Determination 2020/002

Regarding the consented alterations to the walls and roof of a house and its compliance with Building Code Clause B1 at 25 Sturrocks Road, Redwood, Christchurch

Figure 2: Sketch of the revised design based on the amendments to engineer's design sheet SK-2 (not to scale)

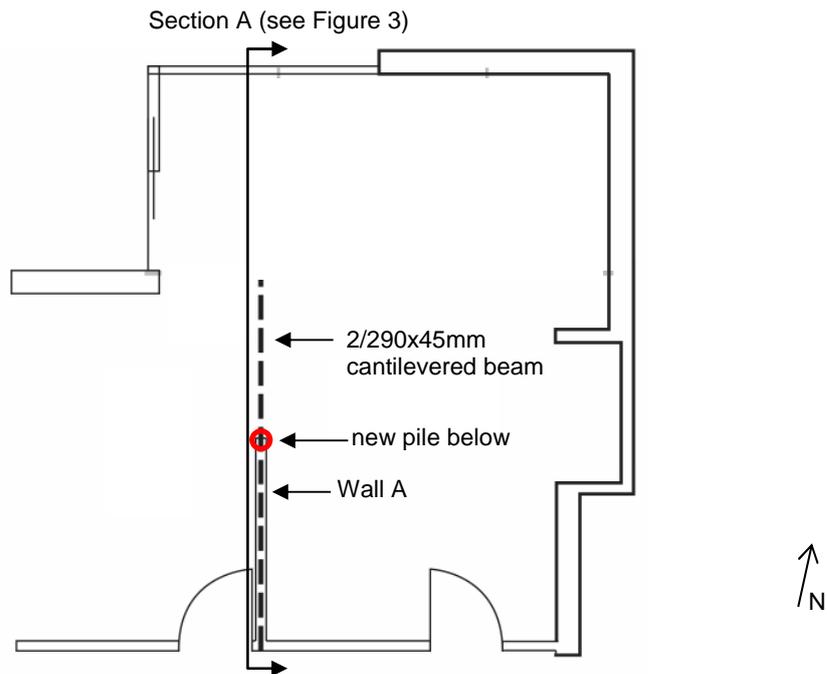
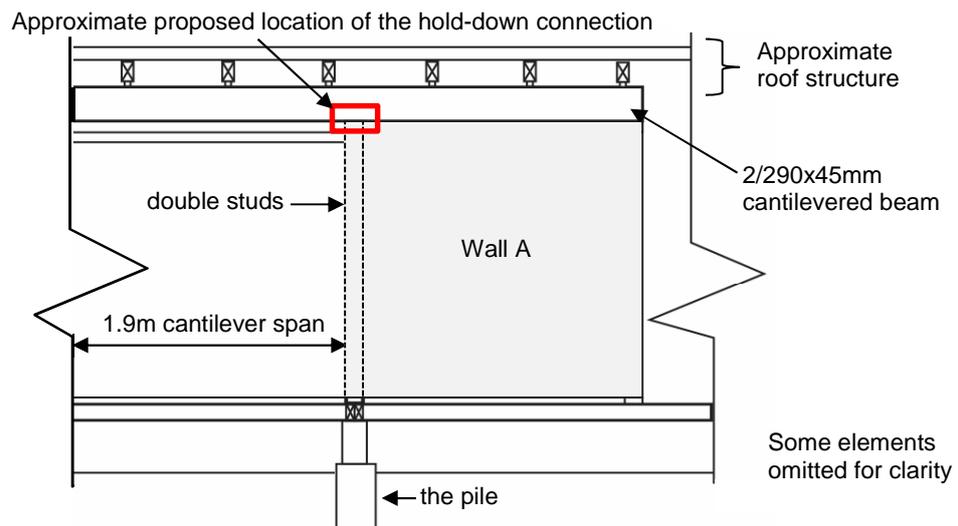
- 2.10 The engineer revised the design to include a single cantilevered beam tied into the existing roof and wall structure (refer Figures 2 and 3). The engineer also confirmed a pile and footing was to be installed under the north end of Wall A between the kitchen and lounge, with double studs above and hold down straps at both the top and bottom on one side. In addition, the south end of Wall A and the end of the cantilevered beam at the hallway were to have hold down straps and blocking “to ensure the stability of the top of the support beam”.

- The two cantilevered beams are not nailed together in a manner that satisfies the requirements of NZS 3604²⁰.
- The hold down connection at the south end of the cantilevered beam is adequate. However, the hold down connection at the midpoint of the cantilevered beam (refer Figure 3) cannot be confirmed as compliant. It is not clear whether the connection continues through the timber blocking into the wall framing below, which is necessary to resist uplift loads.
- After measuring the ceiling slope the second experts calculated the theoretical deflection of the cantilevered beam to be 2.7mm. NZS 1170.0²¹ suggests an appropriate deflection limit for a cantilevered beam as 7.6mm, so the calculated deflection is within the suggested limits.

- While the structural design is straightforward and carried out by the same engineer using similar materials, almost every aspect of the design was altered. The change in design has resulted in a different structural layout; change of beam size; a cantilevered beam used instead of two simply-supported beams with revised support for the roof and ceiling structure. The altered design imposed a greater load on the remaining part of Wall A.

- The calculations provided by the engineer have identified that a hold-down connection is not required to the cantilever beam as there is no net uplift at the base of the beam where it is supported by Wall A (refer Figure 3 – proposed location of hold-down connection) . I agree with this view reached by the engineer and second experts, and consider in this aspect the cantilevered beam complies with Clause B1.

C.4 Photographs from March 2016 provided by the engineer in response to the third draft determination provided on 13 March 2020.

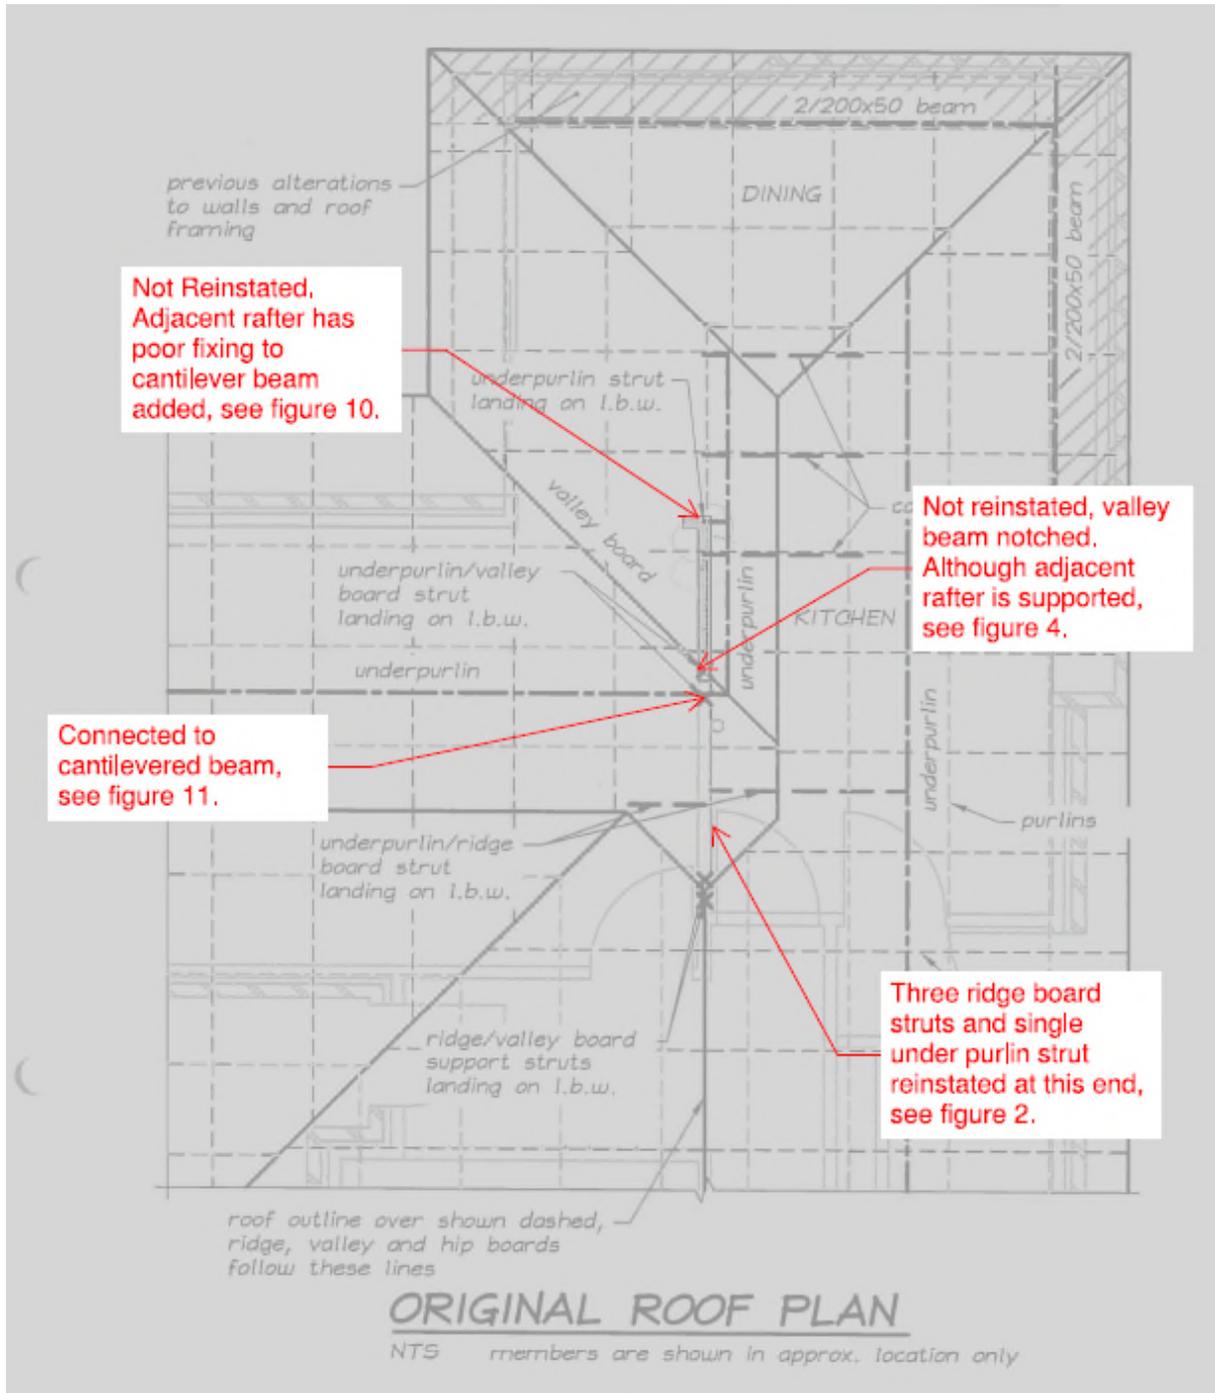
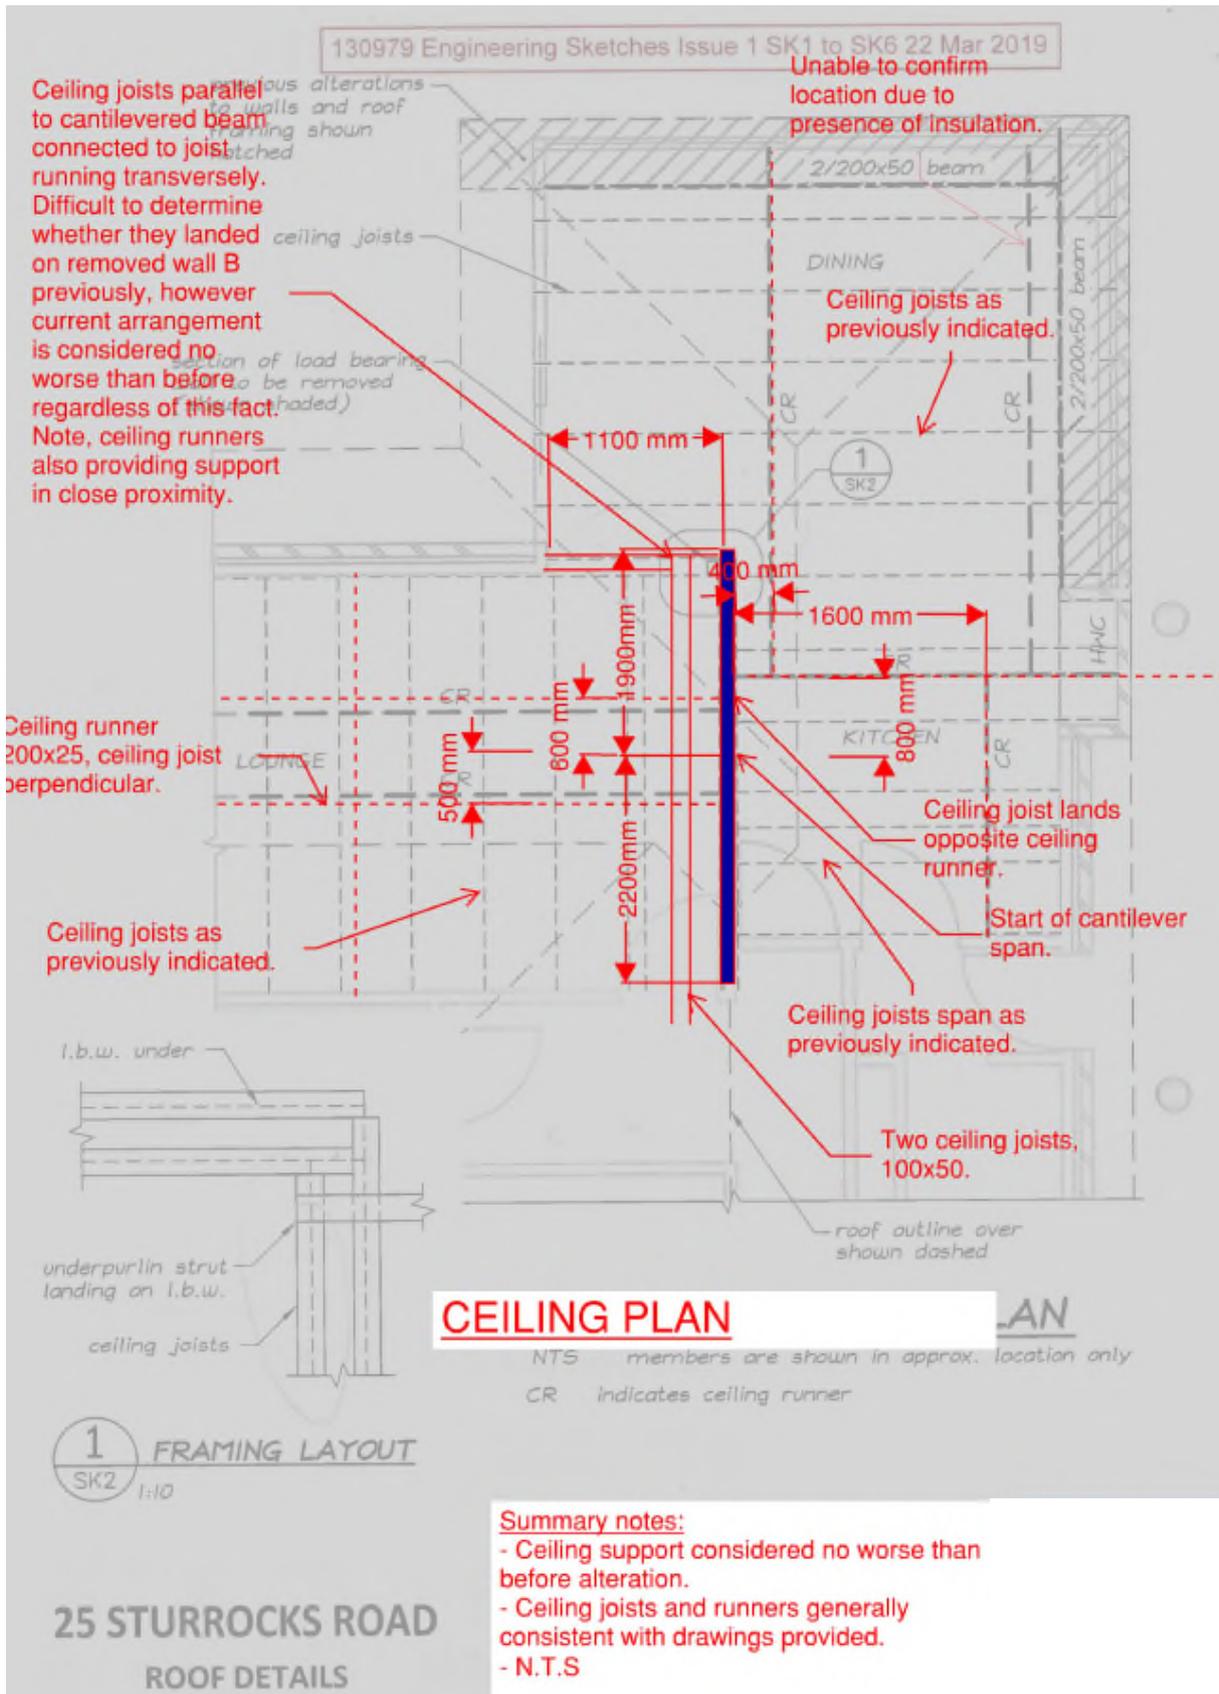
- The second experts agreed with the engineer that there was a sufficient connection between the roof strut and the ridge beam. It is not clear whether there is significant splitting, and if there is it has occurred in the years after the installation. Photographs included with the submission show there was no significant or discernible damage to the roof strut in March 2016. This indicates the roof strut would not have been compromised when the code compliance certificate was issued.

- The roof strut has not complied with Clause B1 for the period of 50 years as required by Clause B2. Regardless of whether there is a sufficient connection between the roof strut and the ridge beam the strut itself is compromised. The videos provided by the owner show significant splitting down the face of the strut. There also appears to be a split on the side adjacent to the ridge beam. Splitting to this extent does not appear to be evident in photographs taken in March 2016 that were provided by the engineer’s lawyer, or in photographs taken in May 2018 and May 2019 by the first and second experts (refer Appendix C – C.1, C.3, and C.4).
